# SAFETY RECALL ALERT

**Bulletin:** SRA-M13-05  
**Date:** December 5, 2013  
**Action Required?** **YES**

**Subject:** Safety Recall, SC0373, L9 Seat Belt Buckles (Revised to correct part numbers on pg 2)

**SALTILLO MEXICO**

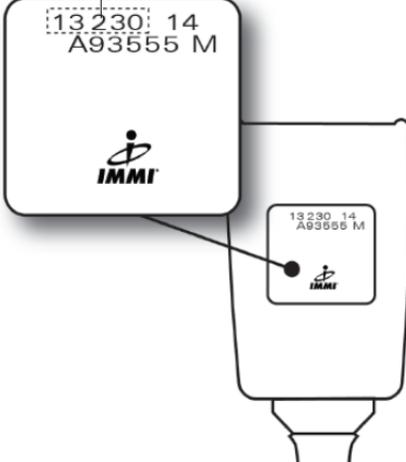
Suspect code range is  
**13220 through 13256**

- 5) If your buckle code is within either of the ranges above, replace your buckle with the substitute buckle.
- 6) If your code does **NOT** fall within either range, you do **NOT** need to replace your buckle.

**WESTFIELD, IN US**

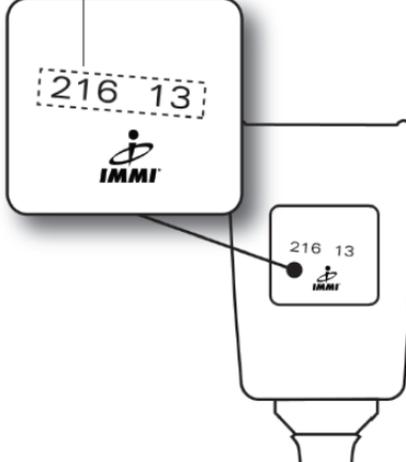
Suspect code range is  
**214 13 through 256 13**
